<b>Location:</b>	<b>2201 Valley Street</b> <b>(See map on reverse)</b>
<b>Assessor's Parcel Numbers:</b>	<b>008-0658-009-01 &amp; -010-00</b>
<b>Proposal:</b>	Design Review discussion for a proposed development that would include a new 450 tall office building including approximately 760,000 square feet of office.
<b>Applicant:</b>	Denise Pinkston / TMG Partners
<b>Owners:</b>	BA1 2201 Valley LLC & Mash Petroleum
<b>Planning Permits Required:</b>	Regular Design Review for new construction, Major Conditional Use Permit for development exceeding 200,000 square feet and 250 feet in height, and Minor Variances for loading berths (6 required; 3 proposed) and tower dimensional regulations.
<b>General Plan:</b>	Central Business District
<b>Zoning:</b>	CBD-P / Height Area 6
<b>Environmental Determination:</b>	Determination Pending
<b>Historic Status:</b>	Not a historic property
<b>City Council District:</b>	3

# 2201 Valley

## Creative Office Building

## 03 - 28 - 2018 HEARING

FROM GRAND AVE LOOKING WEST 2  
at Bay Plaza

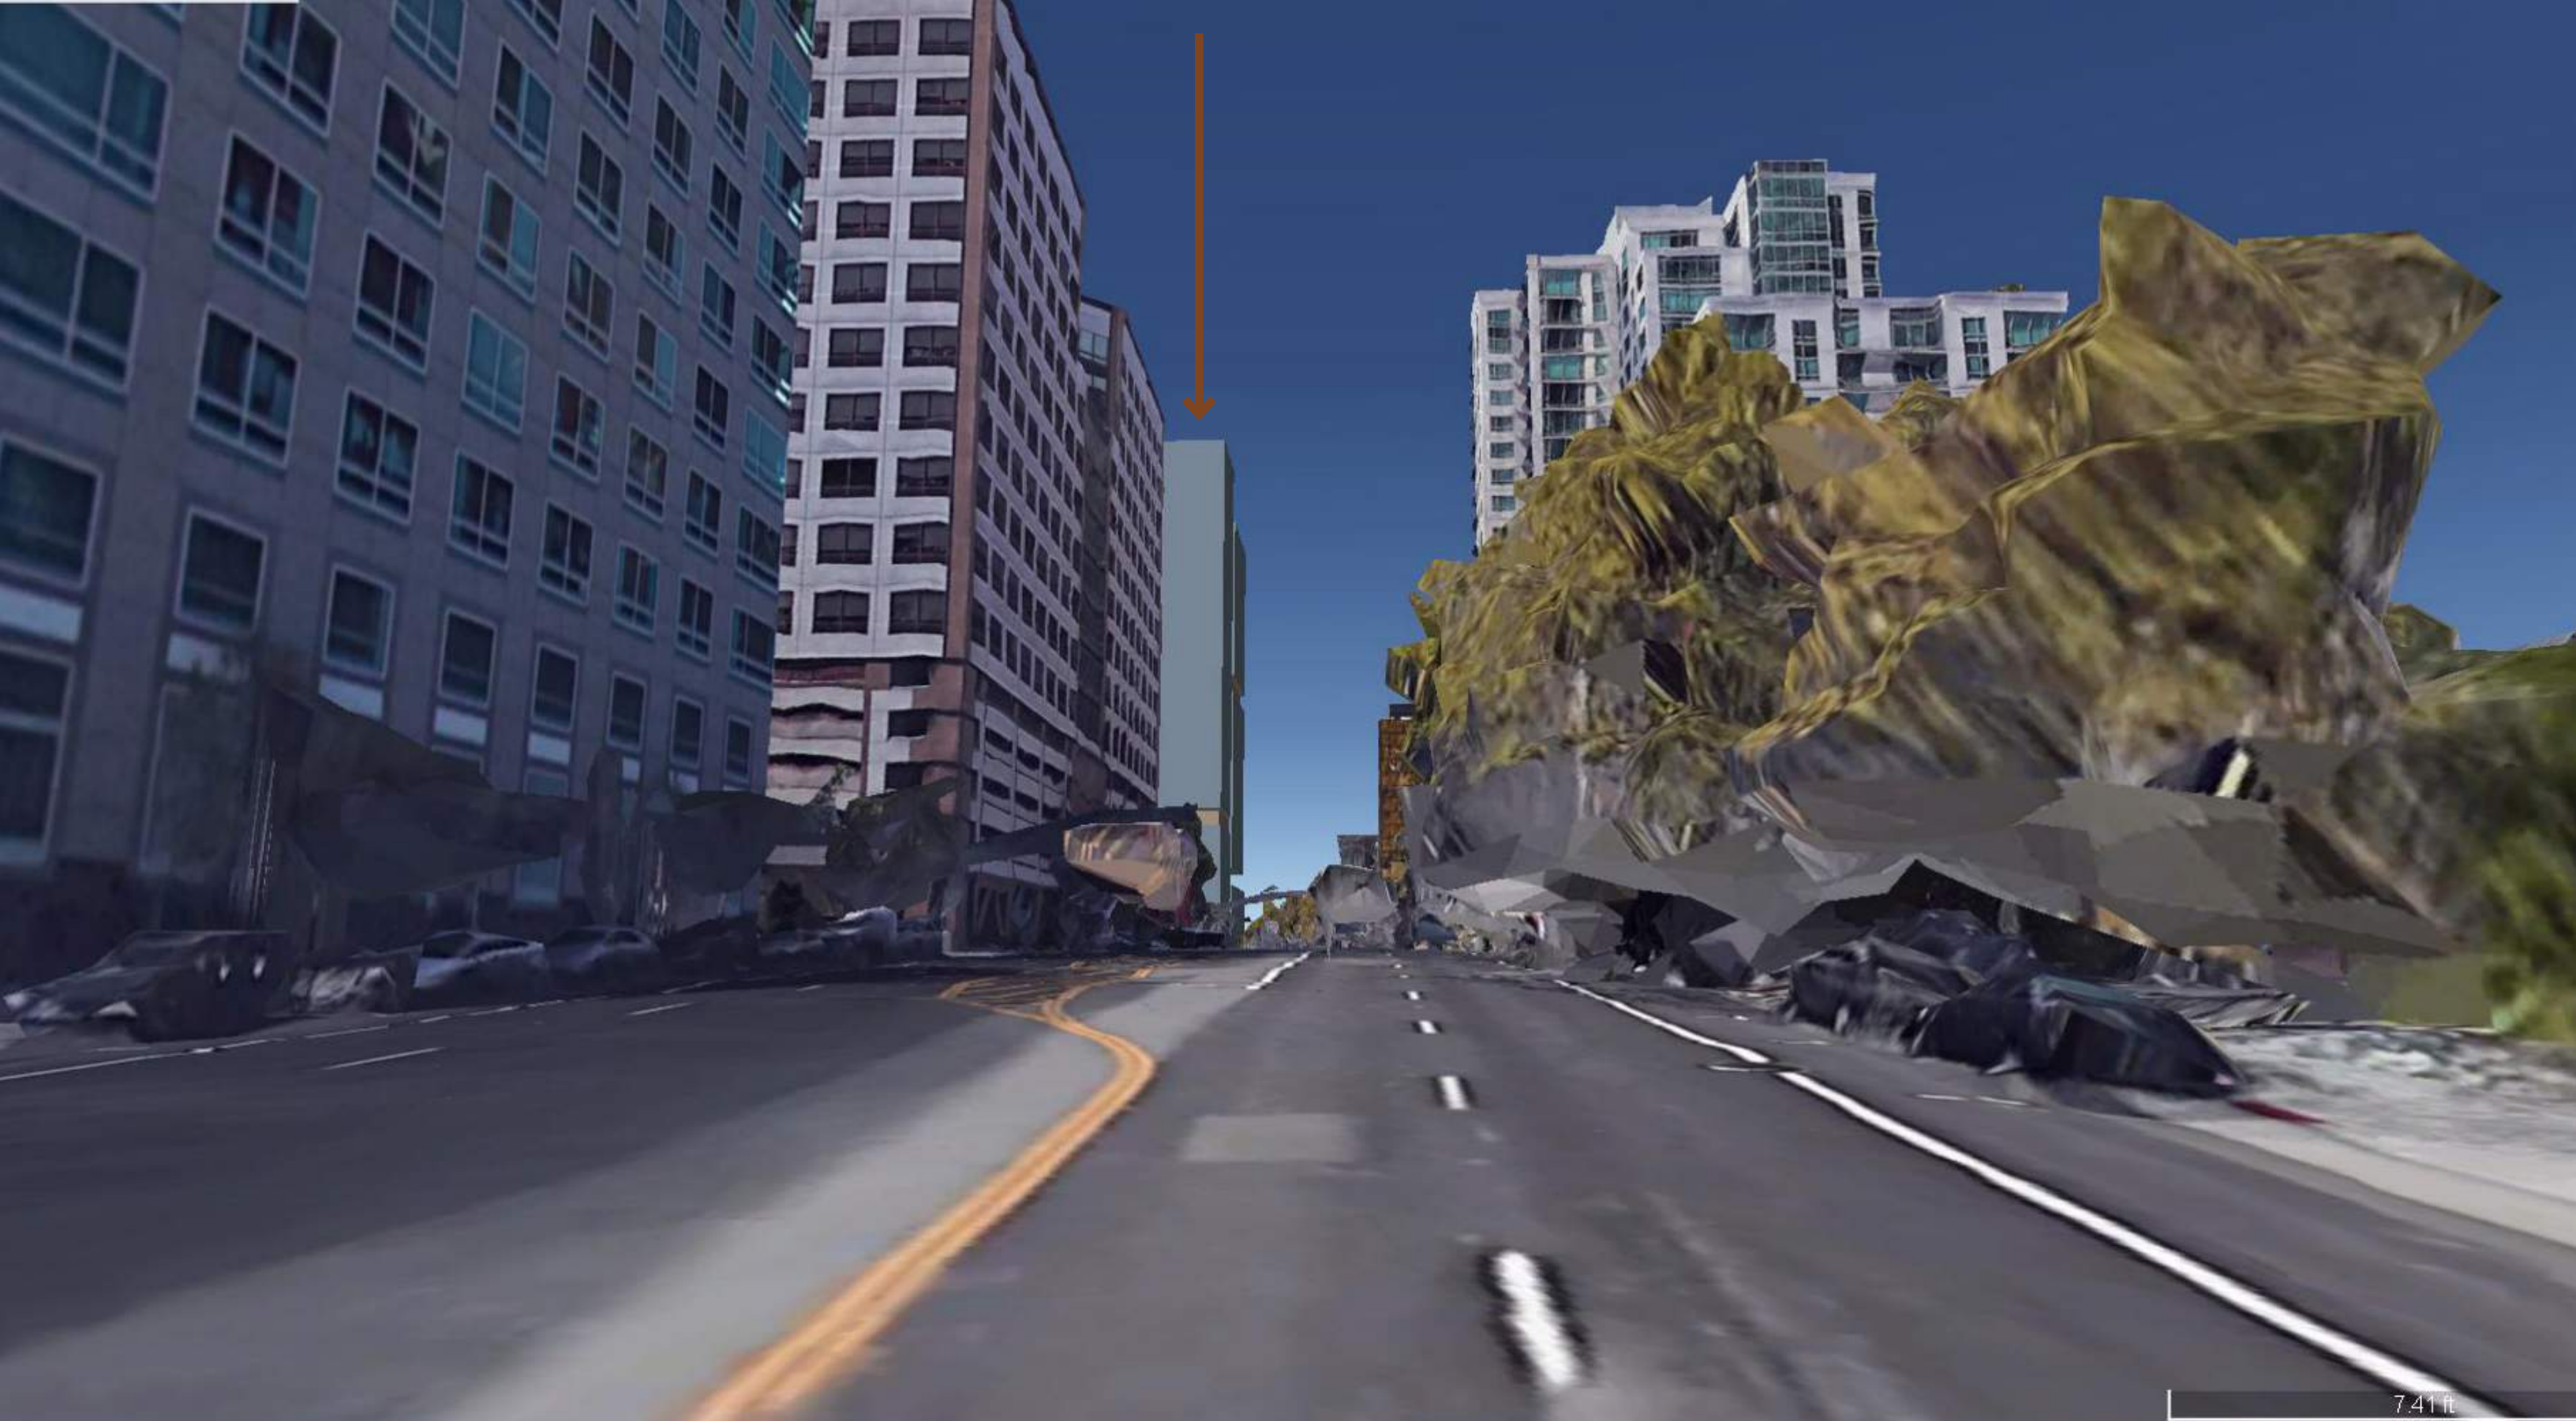
At the prior meeting comments were made about the compatibility of the proposal within the context of the surrounding area as well as the overall skyline view from a distance. The applicant has provided additional images in the plan submittal for consideration and comment.

## 2201 VALLEY & EASTLINE

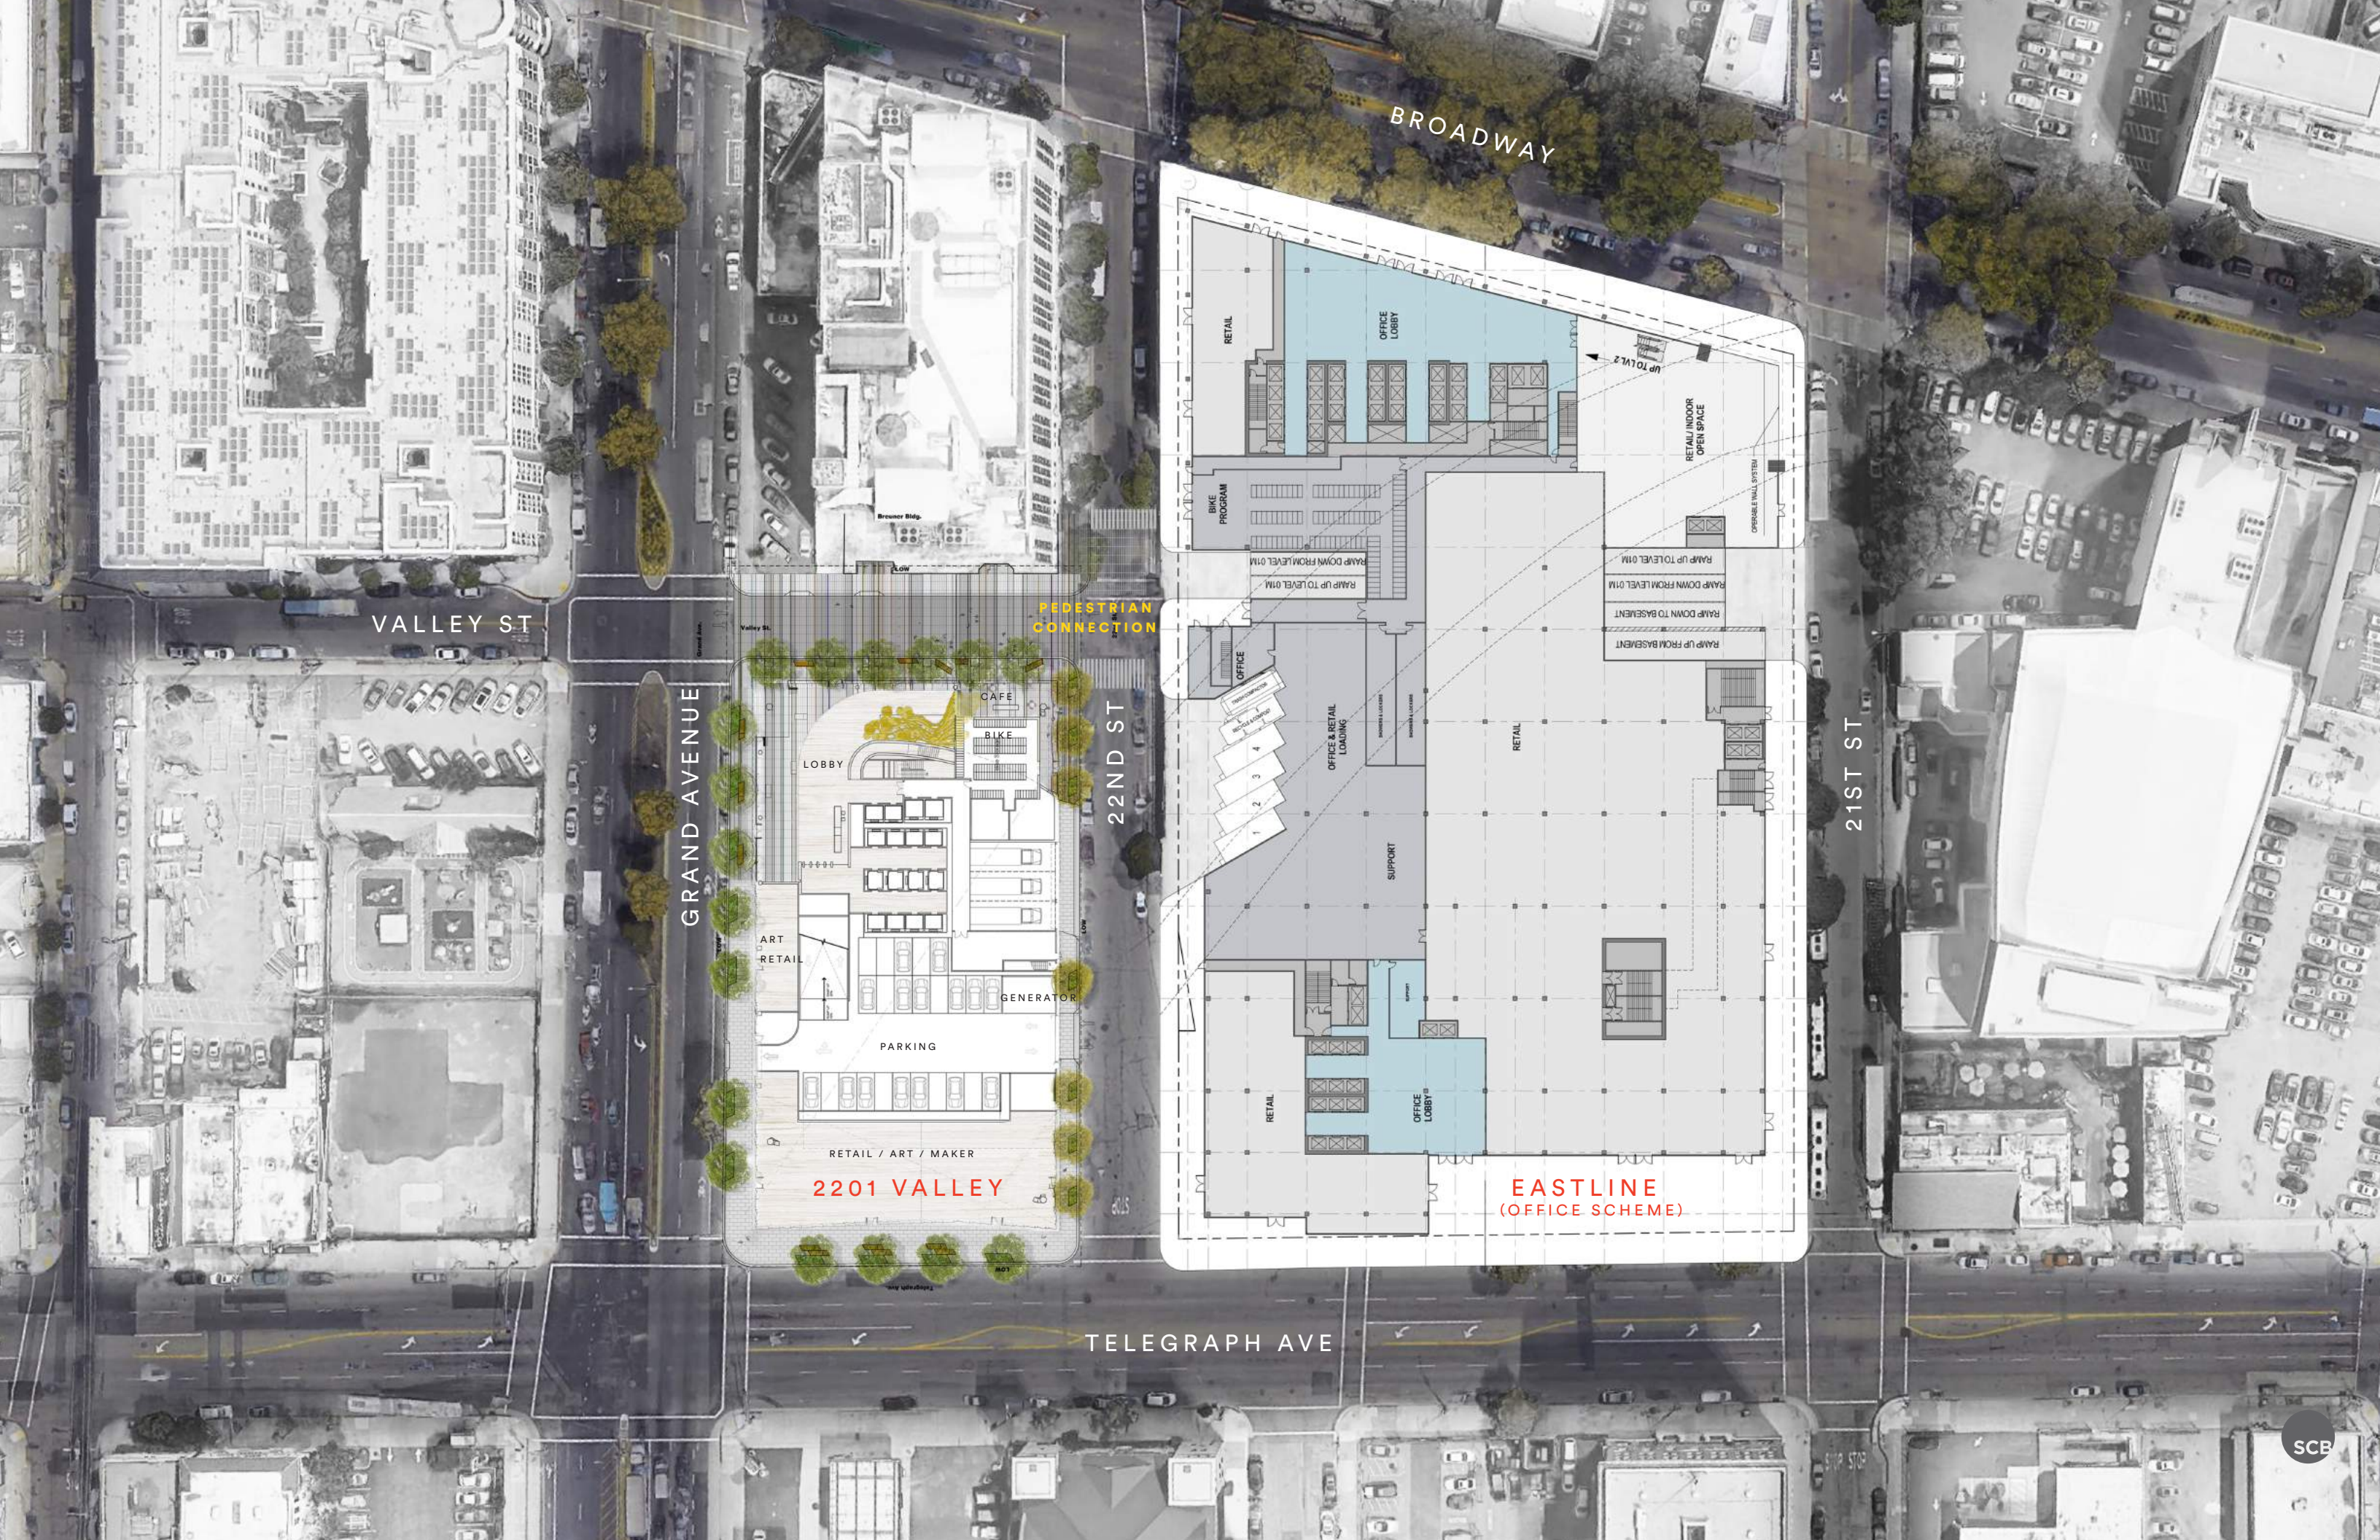
- \_ **CONTEXT VIEW** : Create view from 580, Lake Merrit and Grand Ave.
- \_ **2201 VALLEY & EASTLINE** : Understand the relationship between the 2 buildings especially at ground level.
- \_ **SURROUNDING CONTEXT** : Understand the design decisions and relationship to the neighborhood.
- \_ **PARKING SCREEN** : Reduce visibility of the cars, improve Telegraph edge, perhaps public art.
- \_ **CROWN** : Consider light pollution and other design options.

## PARKING SCREEN

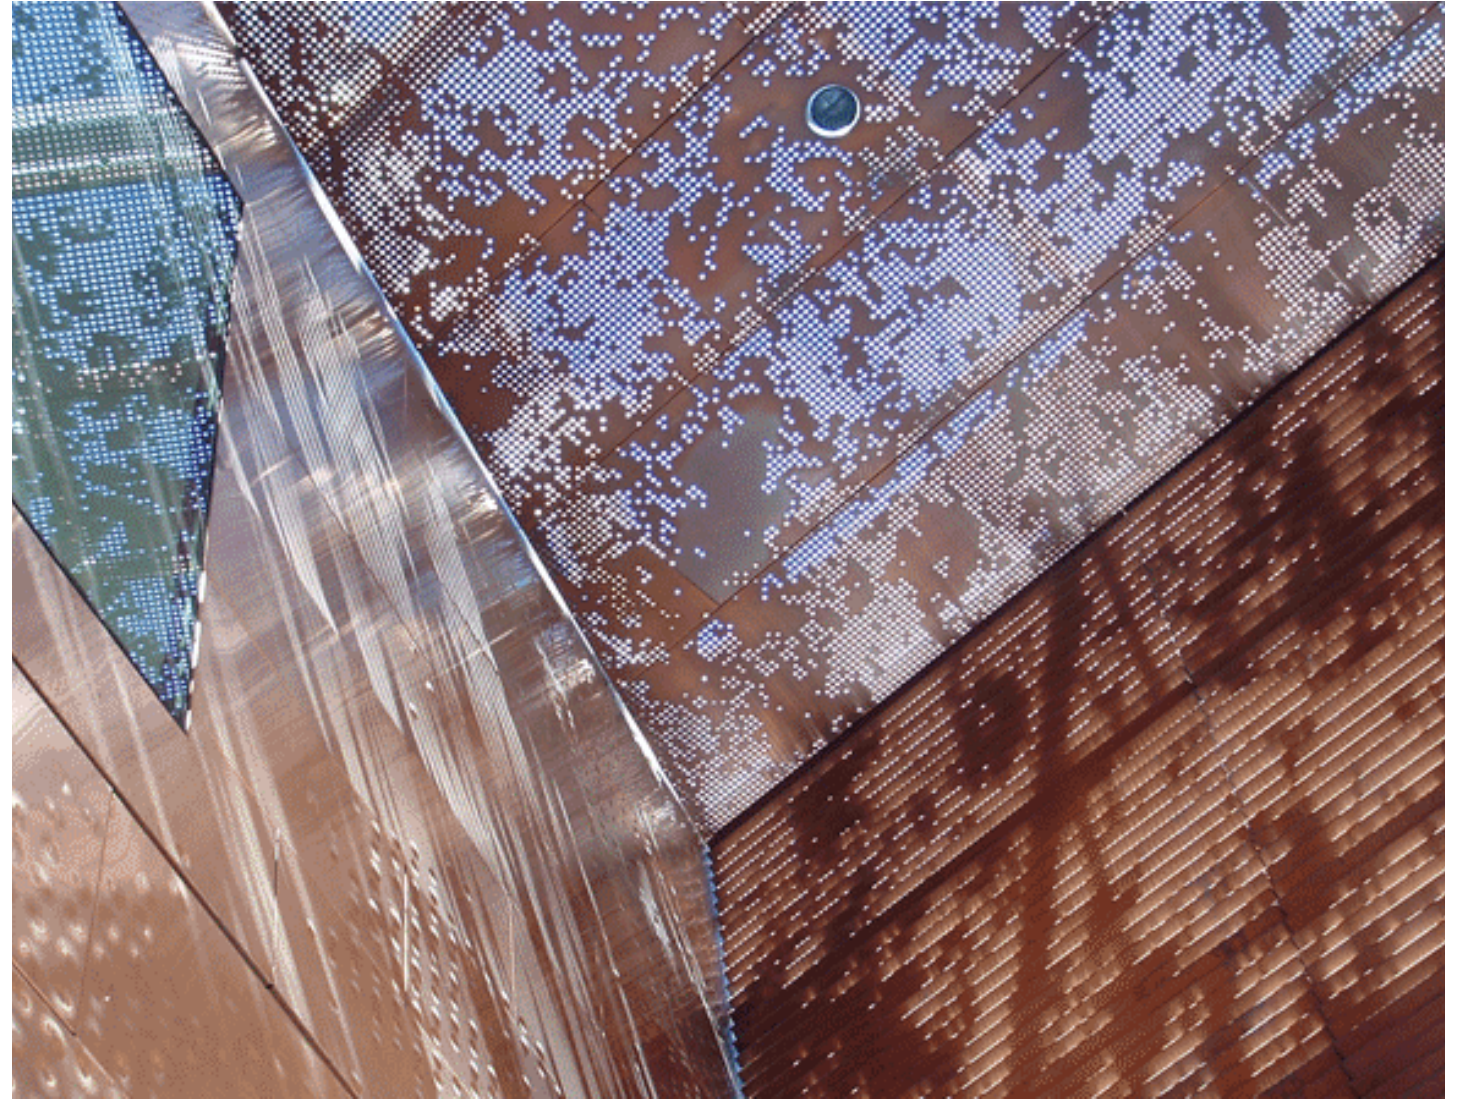
**WE HEARD :** Eliminate view of cars; celebrate the screenwall design along Grand and Telegraph elevations.

**WE ADDED :** Parking screen relationship to the crown screen.
